**NEW ANIMAL SHELTER
225 MAPLE AVENUE
MONTVILLE, CT 06353**

S/P+A PROJECT #22.130

DATE: November 27, 2023

The following changes to the Drawings and Project Specifications shall become a part of the Drawings and Project Specifications; superseding previously issued Drawings and Project Specifications to the extent modified by Addendum #1.

3 FRAME ELEVATIONS

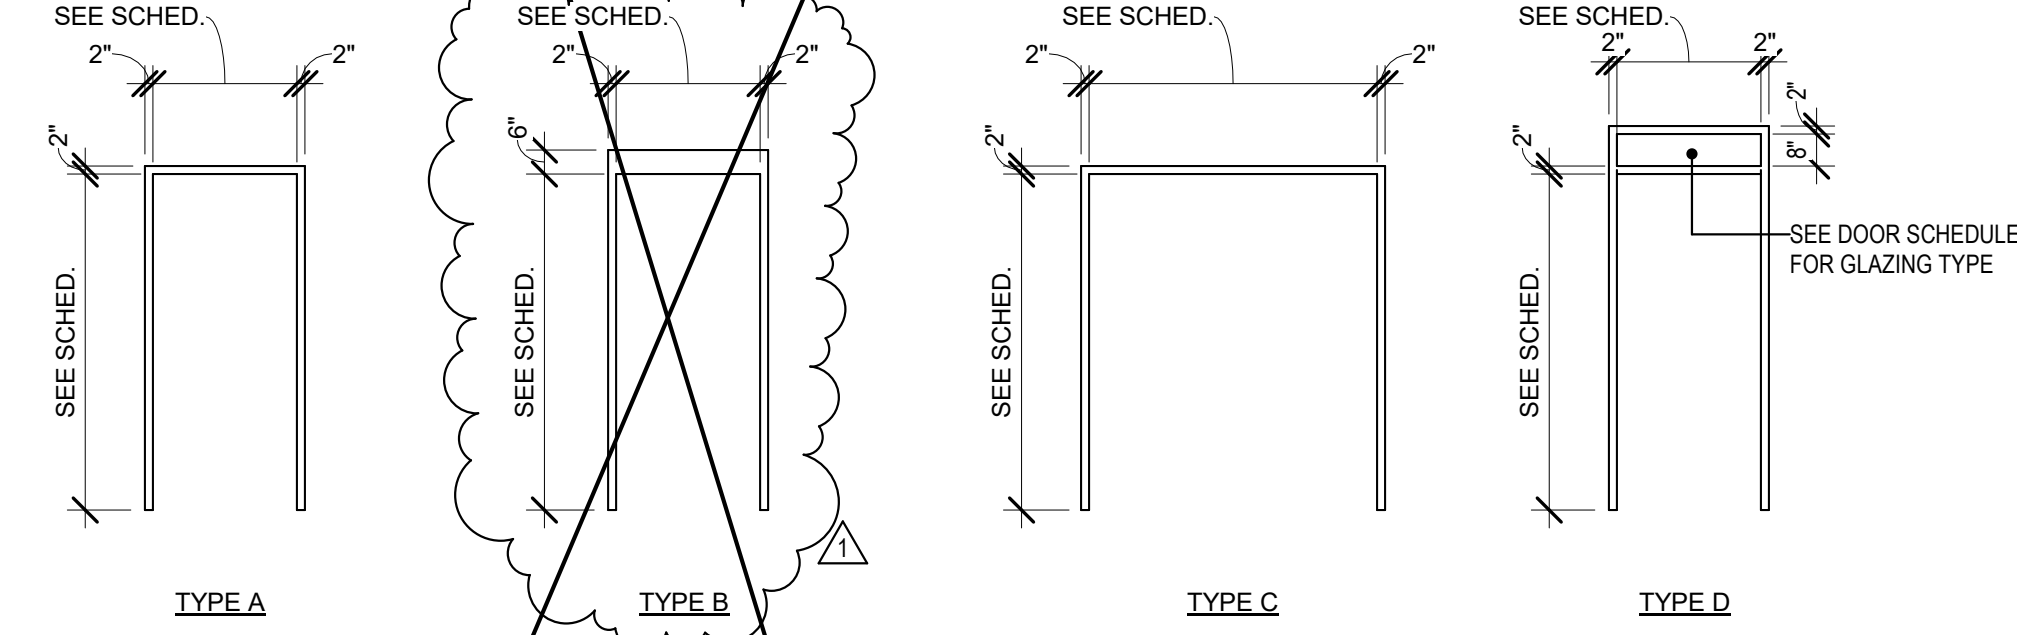
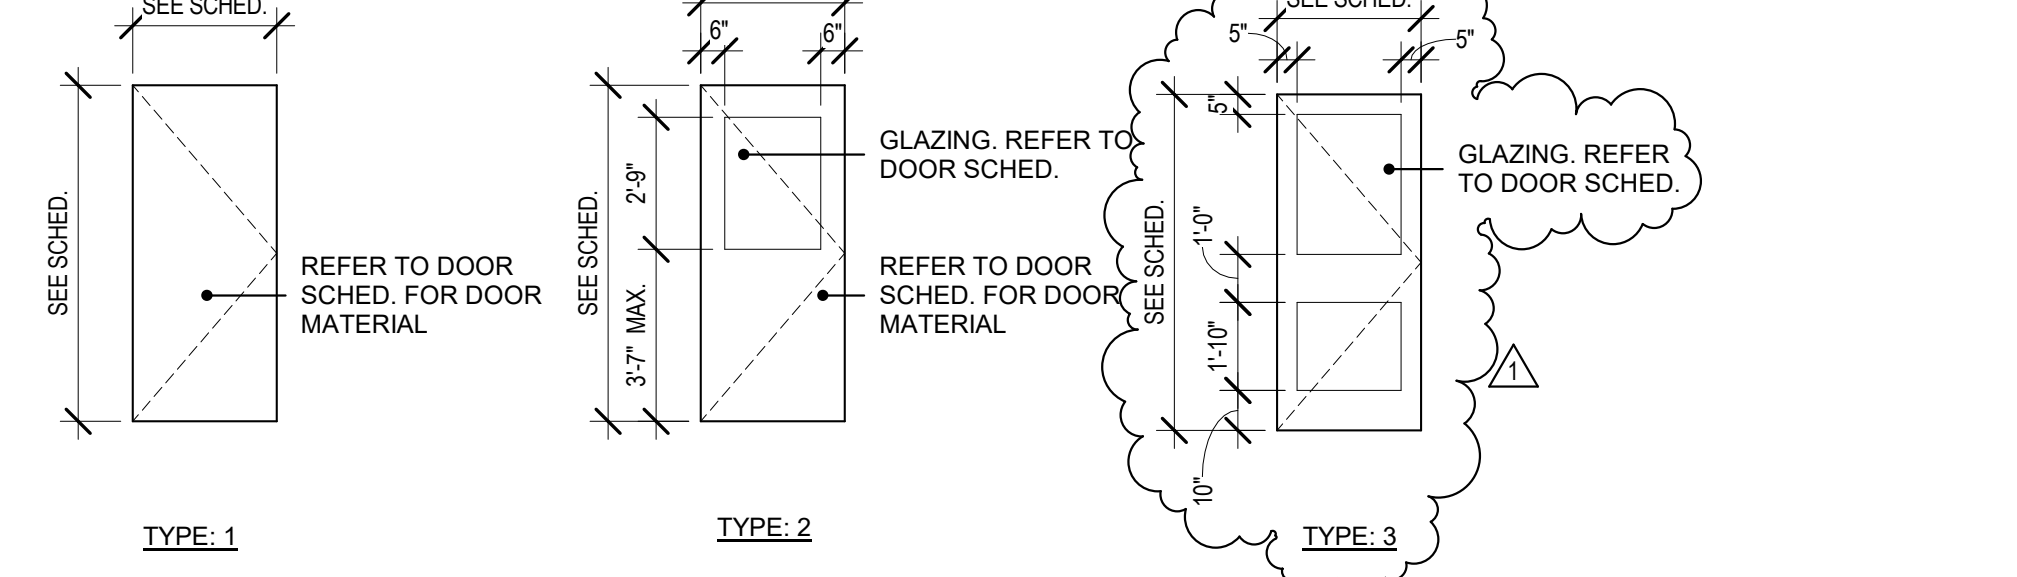
| RFI # | QUESTION | DATE RECEIVED | RESPONSE | ADDENDUM # ISSUED |
|-------|--|---------------|---|-------------------|
| 019 | The door schedule on drawing A900 indicates door 100 to be an aluminum door with a type B frame. Type B frame indicates a 6" frame header which is not offered. Our option would be to stack 2" mullions to achieve the 6" height, but there will be seams visible. Please confirm the stacking is acceptable. If not, please provide alternate direction/detail. | 11/21/23 | Door 100 frame to be Type C. | 1 |
